**20200221**

**RE: East District Skate Park**

**Bob MacQuarrie Recreation Complex, 1490 Youville Drive, Ottawa**

Figure 1: Illustration depicting recommended modifications to proposed Option 3

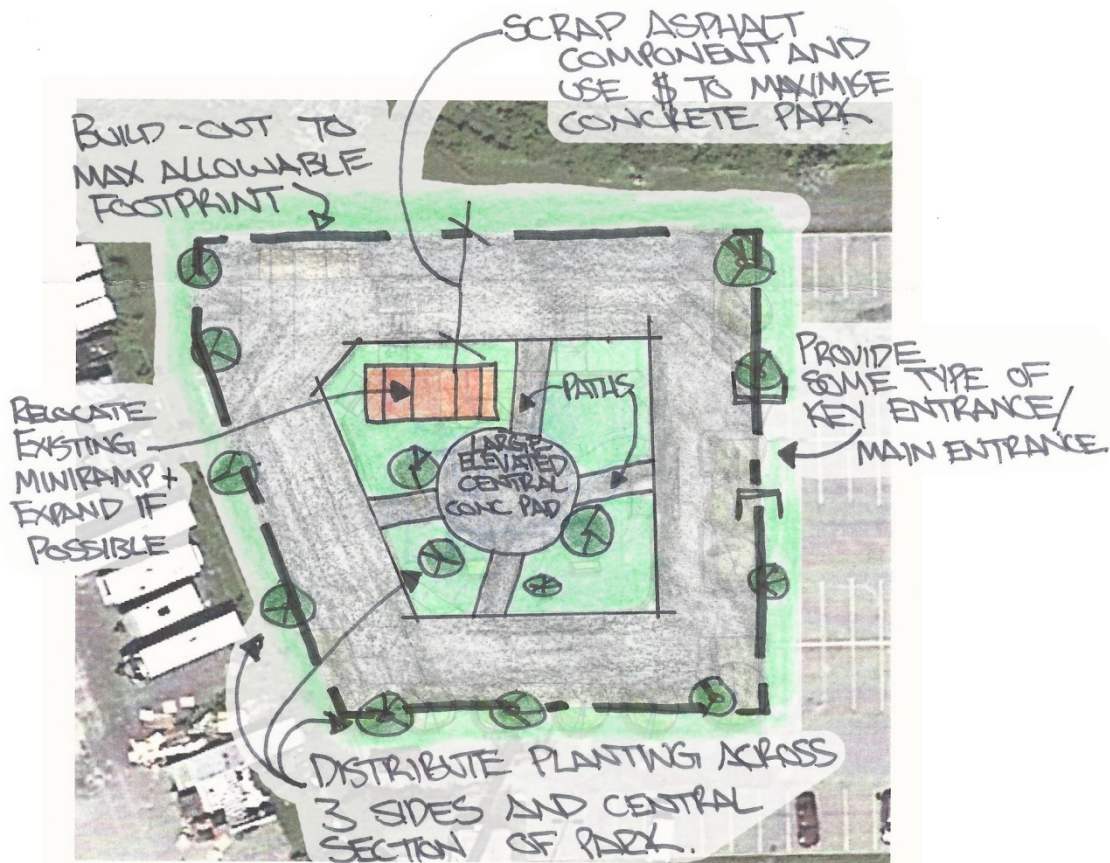
- **Asphalt Resurfacing** - Given the limited budget available for the new park, we understand that incorporating the existing obstacles with resurfaced asphalt was intended as a cost saving measure. Based on our experience, mixed surface parks are a poor use of project funds as they begin to deteriorate after a single freeze-thaw cycle. This results in higher maintenance costs as, in order to maintain the usability of the park, consistent remedial repairs are required. **As such, we strongly advise against using asphalt of any kind in the park and instead recommend putting those monies towards additional concrete.**

- **Park Footprint/Boundaries** - As was noted during the consultation, we understand that any area "given up" during construction is likely to be lost should we ever require it in the future. Option 3 provides the best configuration for maximizing the park's footprint and thus retaining that land for future use by the park. **As such, we propose extending the concrete perimeter to the maximum allowable boundaries.**

- **Spectator's Area** - The current Option 3 does not provide a well resolved location for parents and spectators. Conflict between park users, parents, and spectators is a common occurrence and by providing a space that is central, slightly elevated, out of the user's way but still near enough for supervision would greatly reduce these conflicts. **As such, we propose providing a central embankment with a mix of soft and hard-scaping to act as a spectator area and gathering point.**

Figure 2: Illustration describing the design intent of the modifications to proposed Option 3

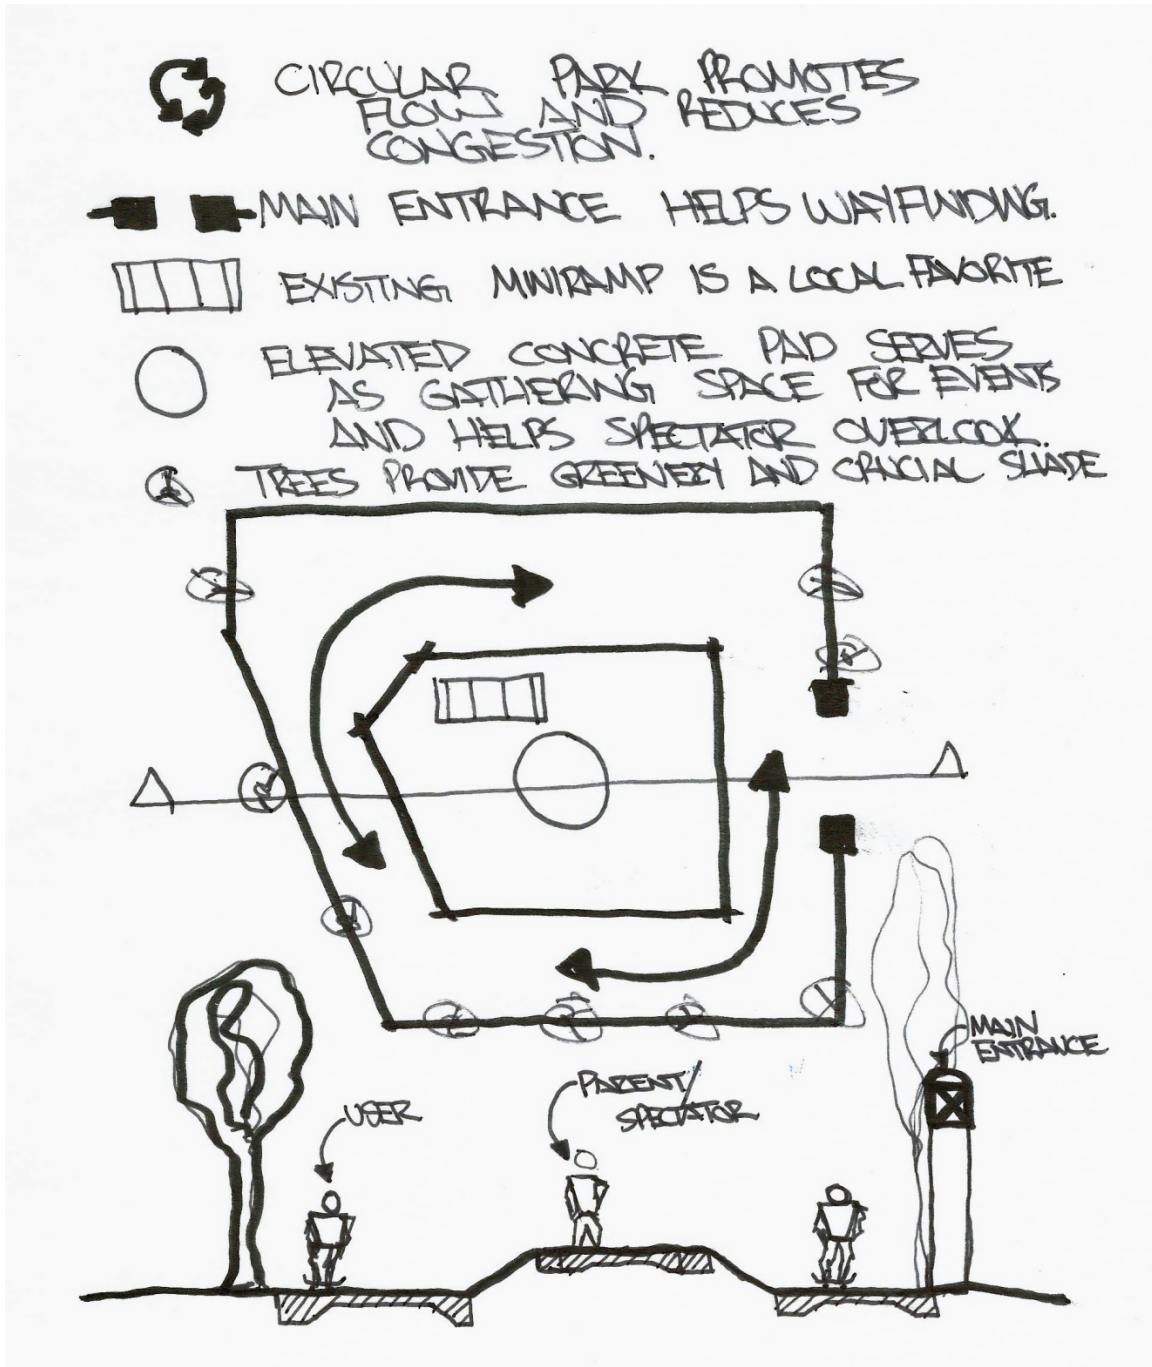
- **Main Entrance** - The current Option 3 does not provide a clearly delineated entrance to the park which is important for wayfinding and orienting oneself in the space. **As such, we propose adding a clear “main” entrance to either the South or East sides of the park.**

- **Vegetation/Natural Shading** - The current Option 3 provides much needed, but seemingly limited amounts of natural vegetation, especially to the West. **As such, we propose increasing the number of trees and vegetation along the West/South/East perimeter and in the proposed Spectator’s Area.**

- **Utilizing Existing Components** - In consulting with local Orleans skaters, we have come across notable support for incorporating and expanding if possible, the existing miniramp. **As such, we propose incorporating the existing miniramp in the new central Spectator Area complete with a compacted, crushed gravel base or equivalent to ensure and maintain level installation.**

- **Use/Flow** - A major strength of Option 3 as it was presented and as modified is the layout provides a circular flow or navigation. A good circular flow allows the park to be used in either clockwise or counterclockwise directions and reduces user conflicts resulting from traffic jams and cross-traffic riding. **As such, we propose an obstacle layout that facilitates continuous usage in either direction.**

Figure 3: Potential Phase 01/02 split

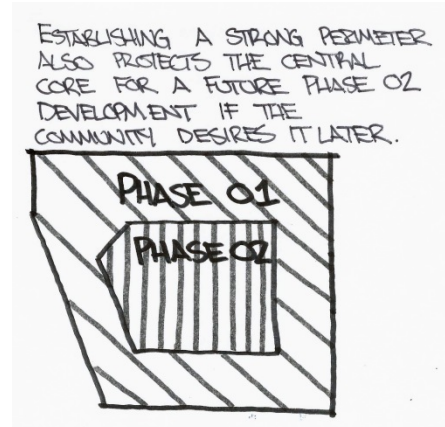
- **Expansion/Future Considerations** - Given the current budget constraints, we believe that a modified Option 3 also provides the best layout for expansion in the future. The outer perimeter could remain entirely or largely in use while Phase 2 is undertaken in the central core.
- **Thematic Considerations** - As one of a number of skateparks currently under consideration, the OSA has been pushing
